SUBJECT: FORWARDS REQUEST FOR AMEND TO APP A OF LICENSE DPR-31 &
 DPR-41. AMEND COVERS CHANGING TECH SPEC LIMITS RE ECCS
 COOLING PERFORMANCE IN LIGHT OF WESTINGHOUSE REEVALUATION.

Re: Turkey Point Units 3 and 4
Docket Nos. 50-250 and 50-251
Proposed Amendment to Facility
Operating Licenses DPR-31 and DPR-41

Re: Turkey Point Units 3 & 4
Docket Nos. 50-250 & 50-251
Revised ECCS Analysis

Figures 3.2-2, 3.2-2a, and 3.2-2b

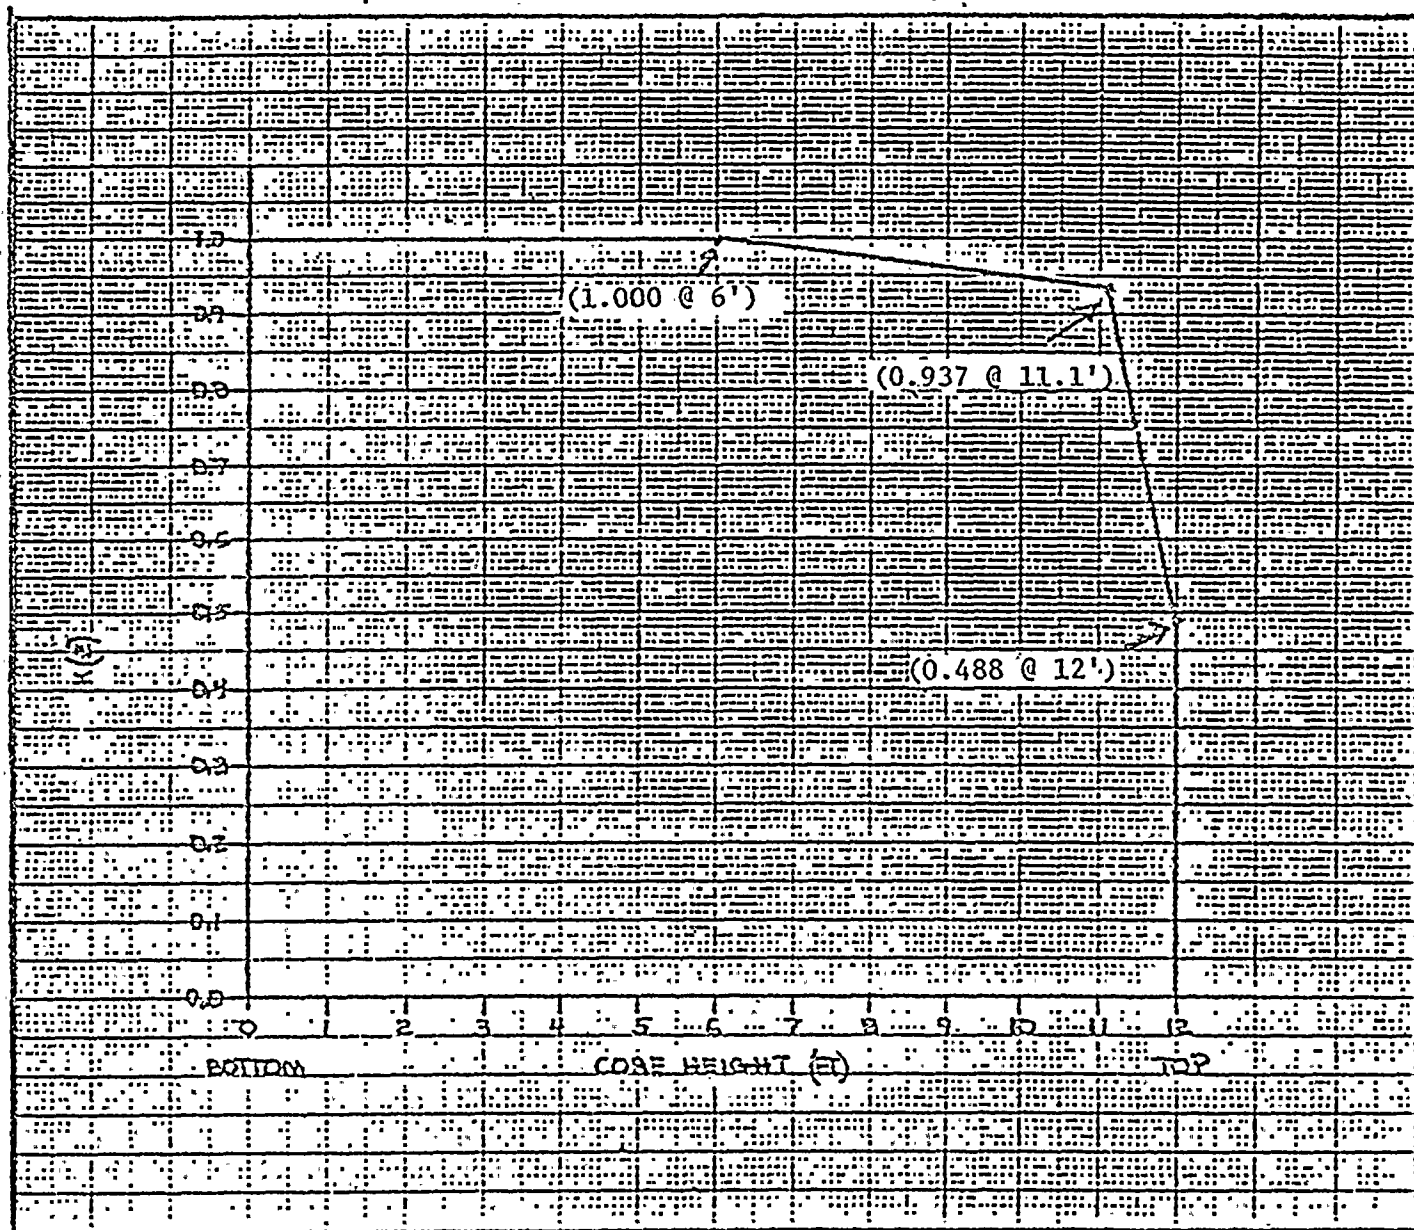
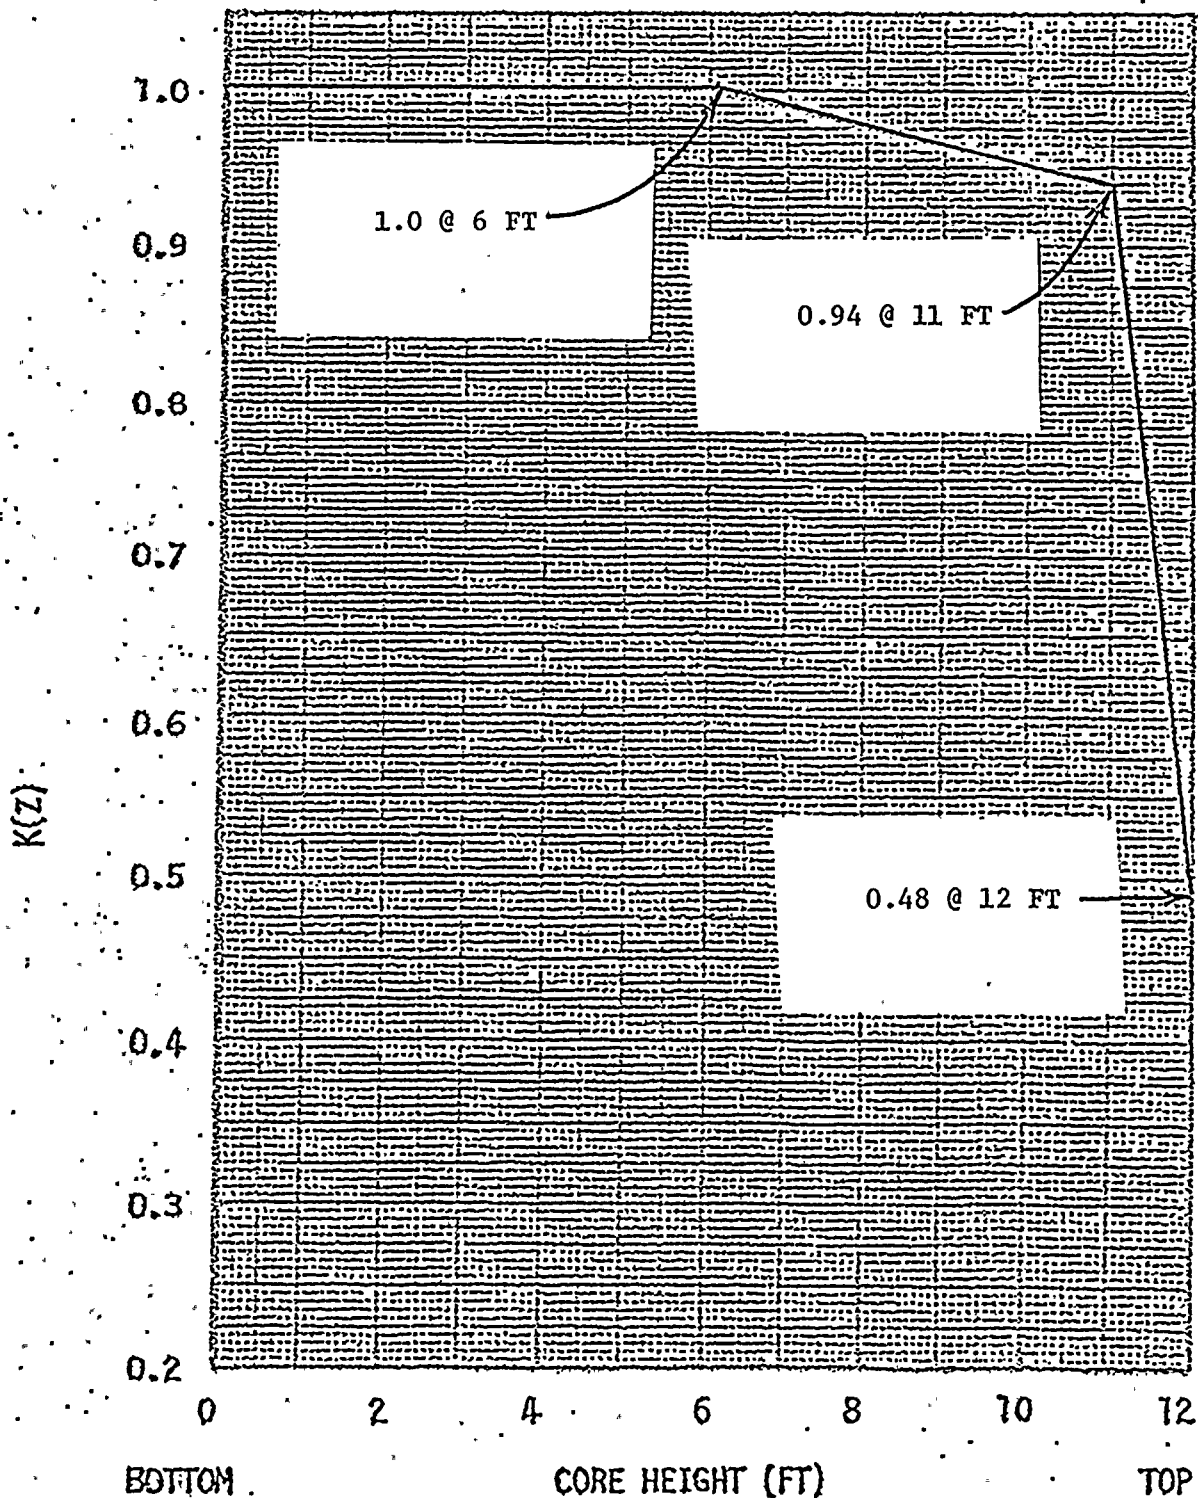
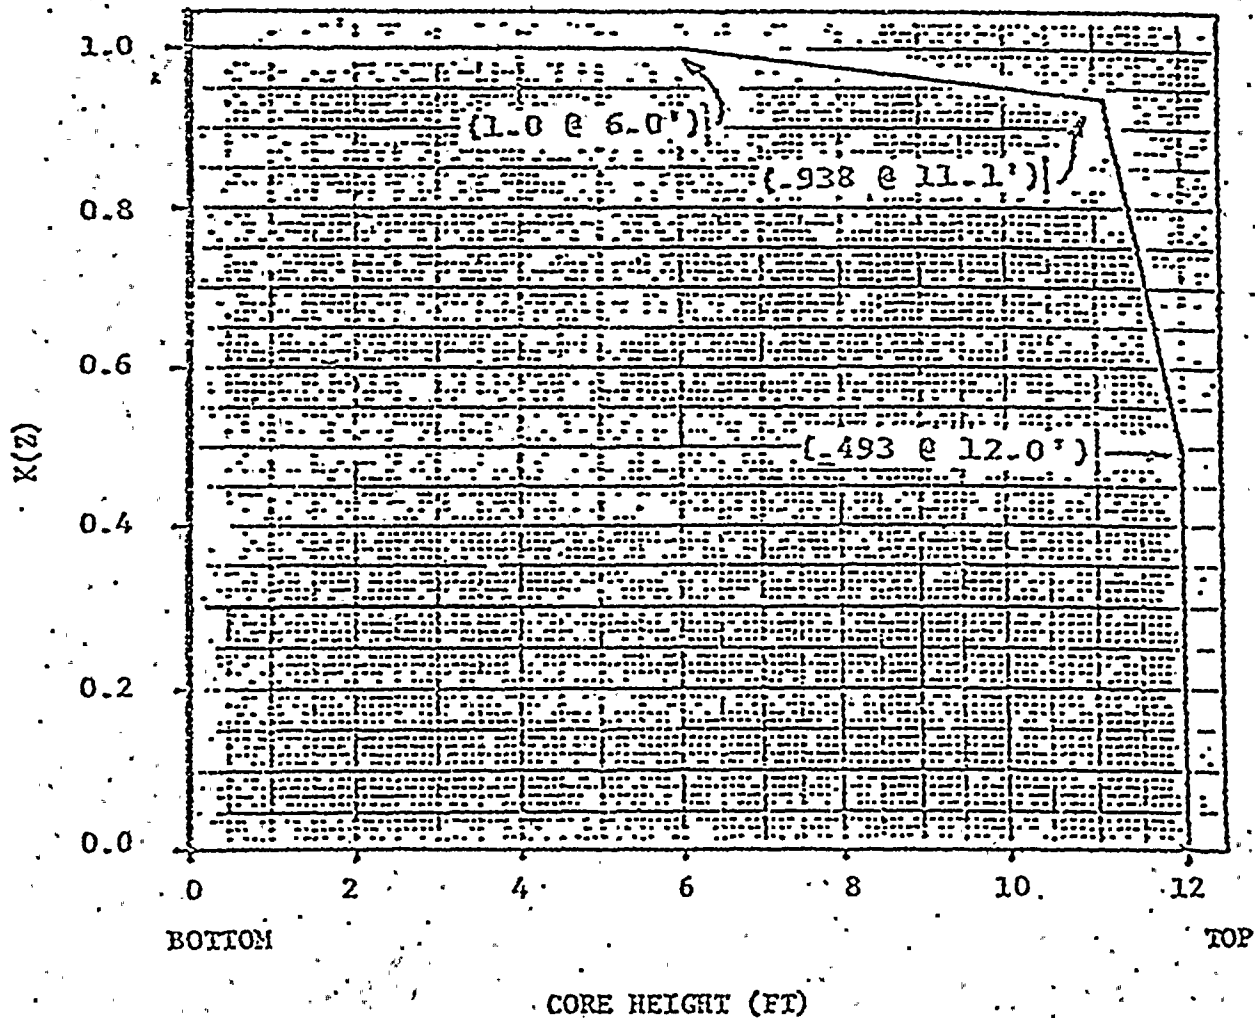
The two existing figures are renumbered and a third figure is added to provide successive Hot Channel Factor operating envelopes for 19%, 22%, and 25% steam generator tube plugging.

Bases Section B3.2 (Control and Power Distribution Limits) is revised to include reference to Figure 3.2-2a and 3.2-2b.

HOT CHANNEL FACTOR
NORMALIZED OPERATING
ENVELOPE (FOR TUBE PLUGGING
>15% ≤19%)

HOT CHANNEL FACTOR - NORMALIZED
OPERATING ENVELOPE (for
steam generator tube plugging
22% and $F_q = 2.10$)

HOT CHANNEL FACTOR-NORMALIZED
 OPERATING ENVELOPE (FOR STEAM
 GENERATOR TUBE PLUGGING $\leq 25\%$ and $F_q = 2.03$)
